ANALYSIS

**EXHIBIT A
DEPARTMENT REVIEWS**

General RV Site Plan Amendment

14295 S. Minuteman Drive

EXHIBIT G
LANDSCAPE PLAN

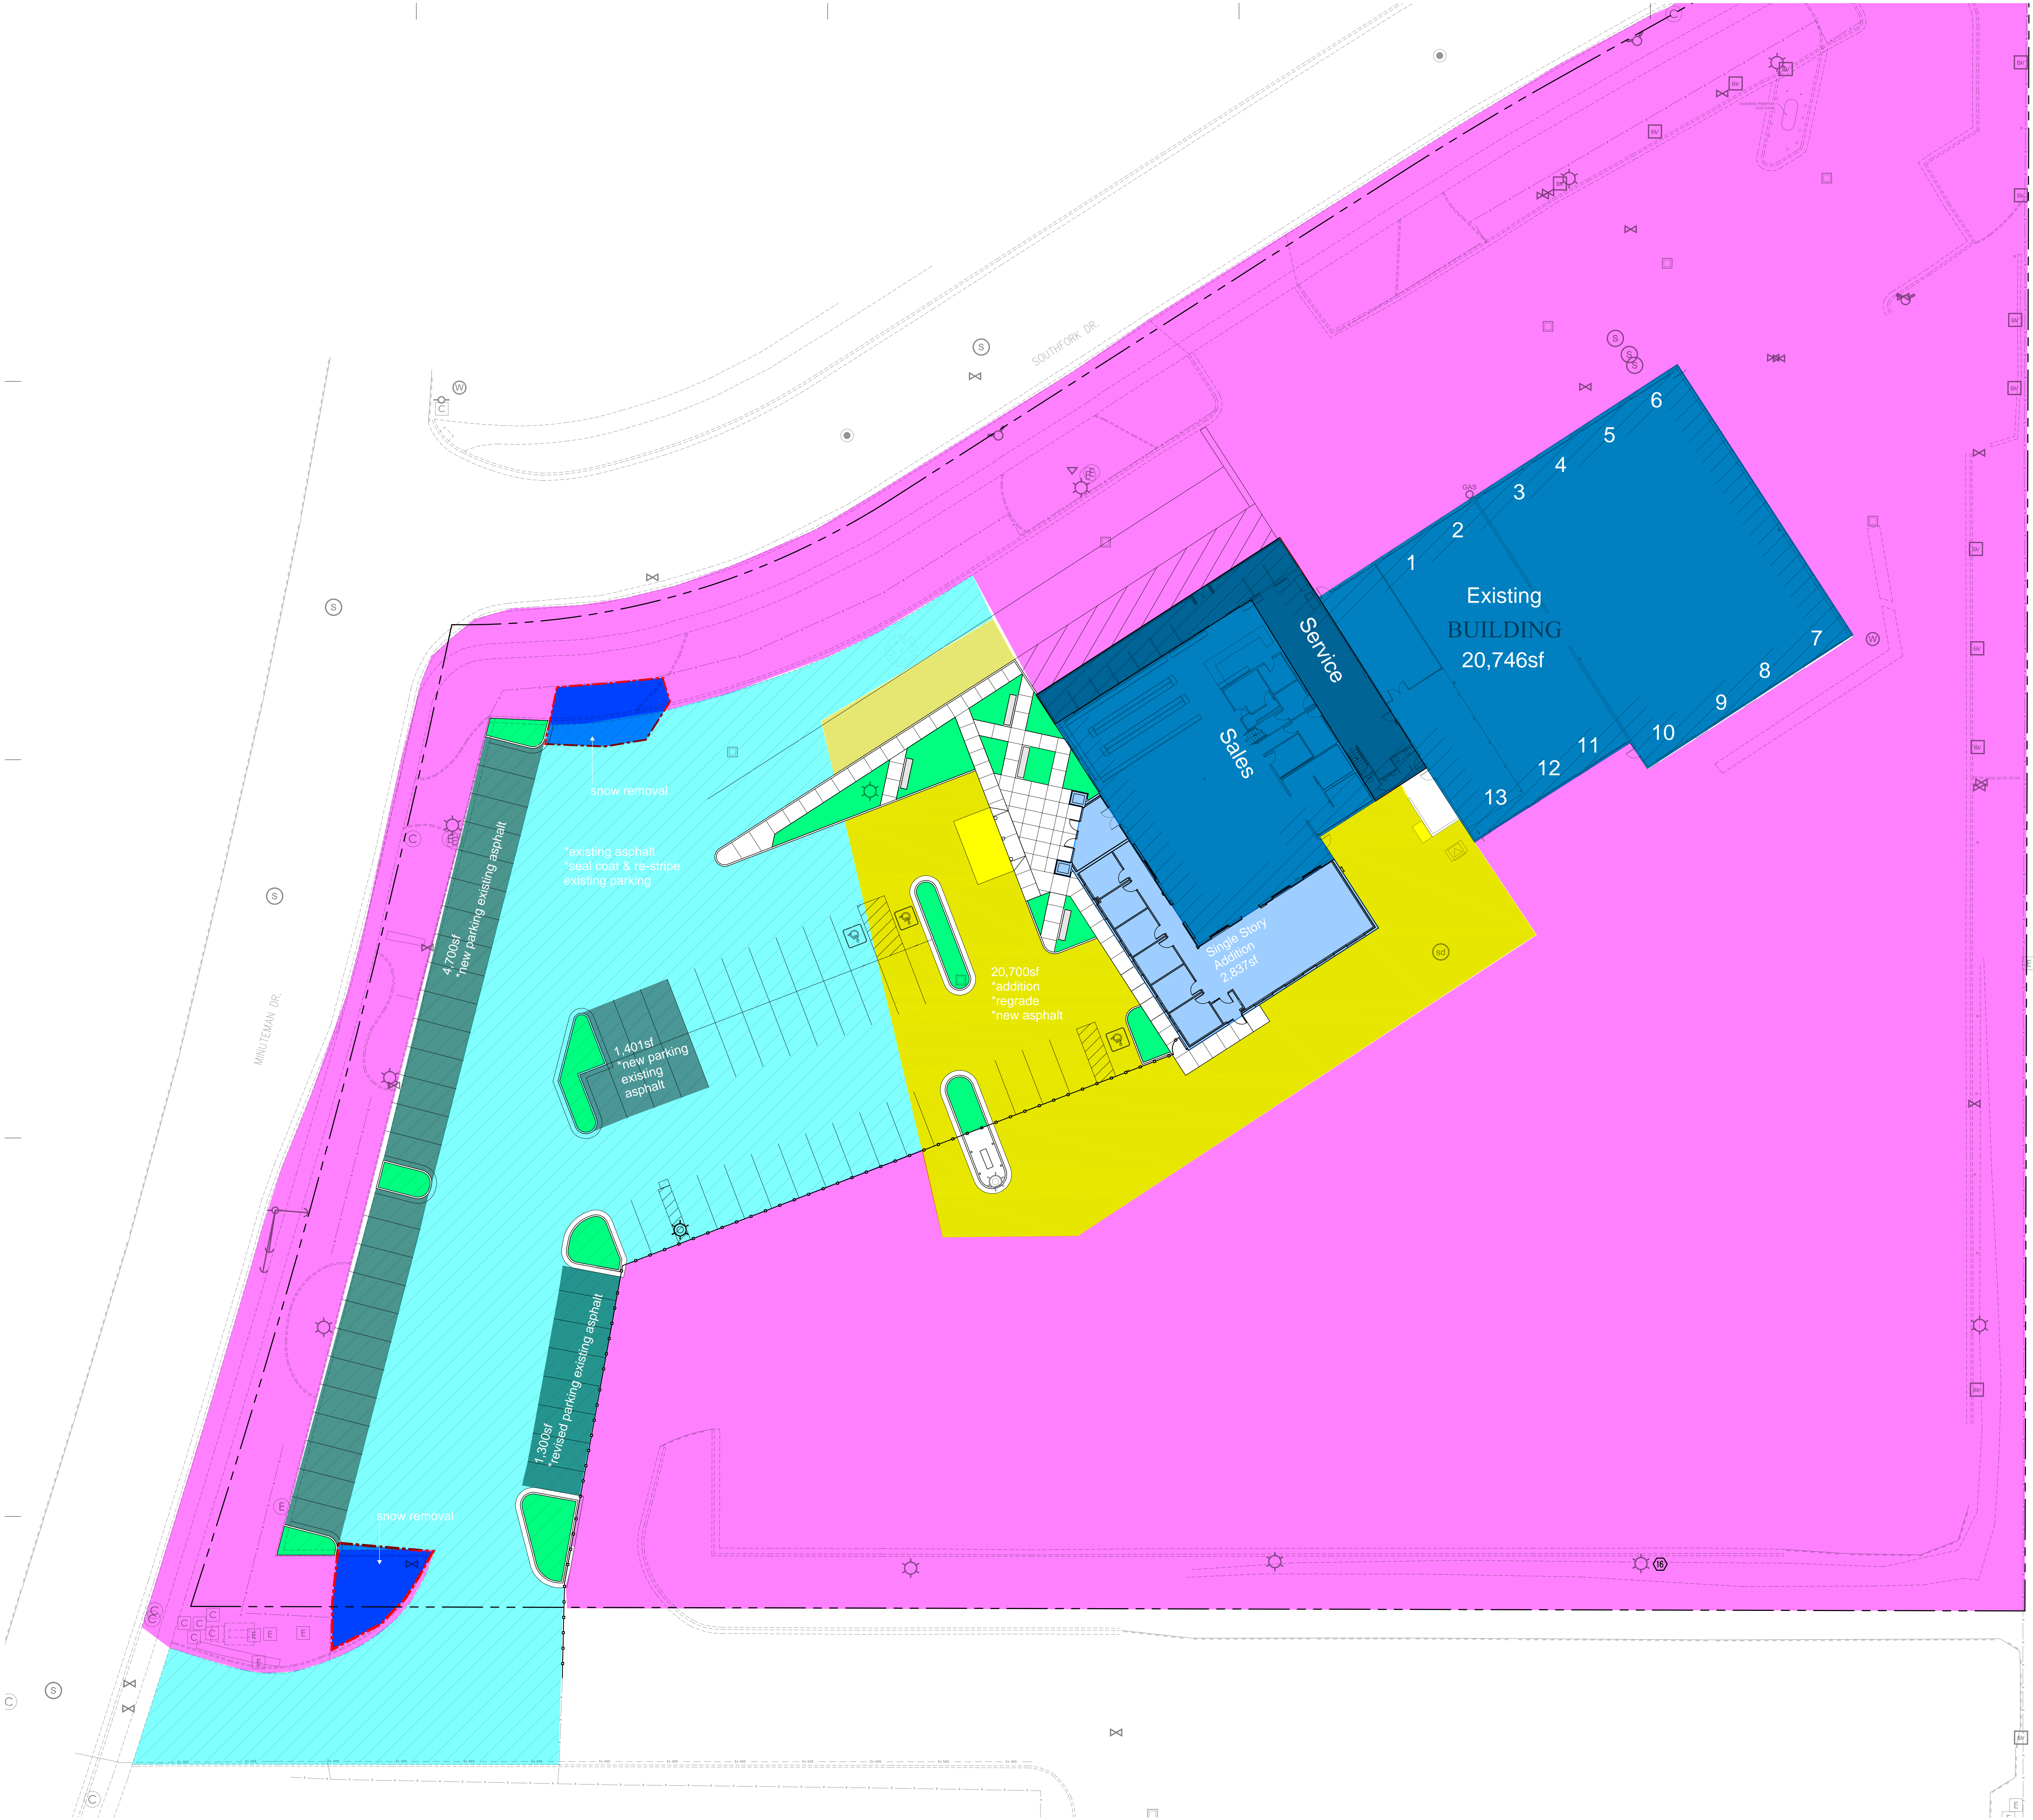
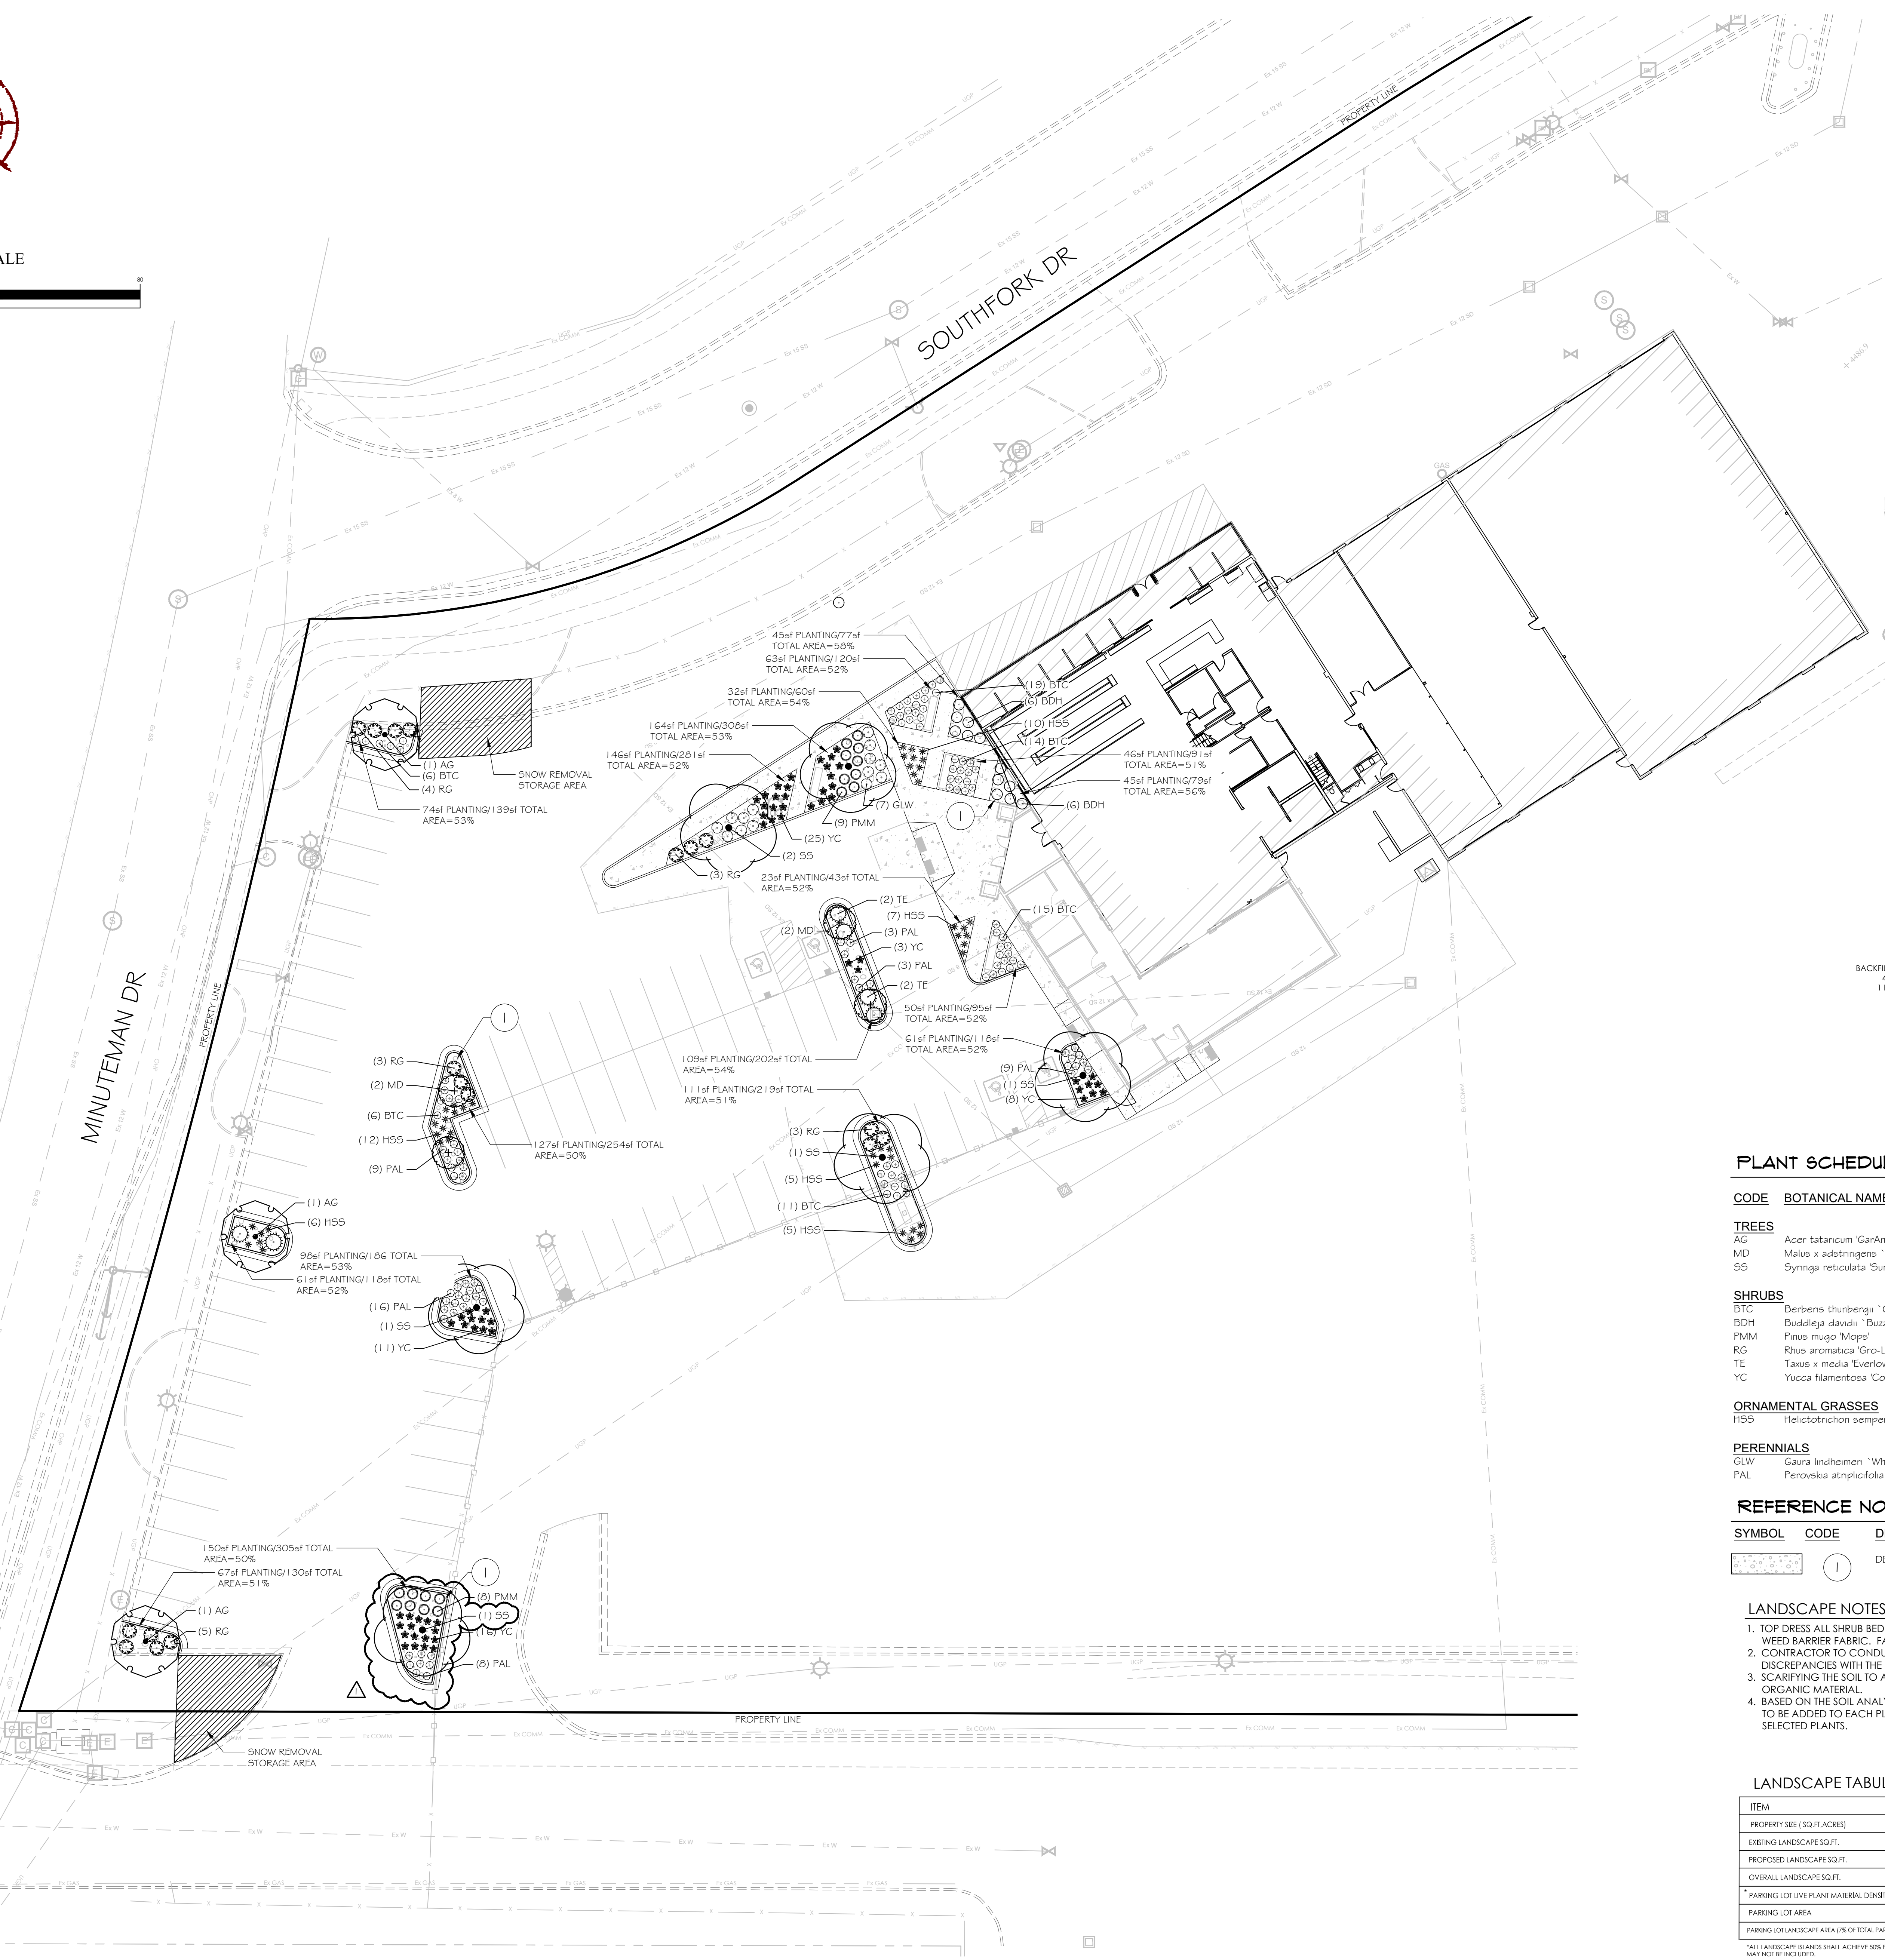
Landscaping. The Landscape Plan (Exhibit G) shows that 2,958 ft² of landscaping is proposed to be added at the front of the building and within the parking lot. There is 40,720 ft² of existing landscaping along both street frontages and along the south and east property lines. The areas of the parking lot that have been modified will be brought into compliance with the parking lot landscaping standards by adding landscaped islands at the end of each row and between rows of stalls. The disturbance area does not propose to modify the existing perimeter landscaping, buffers, or street trees.
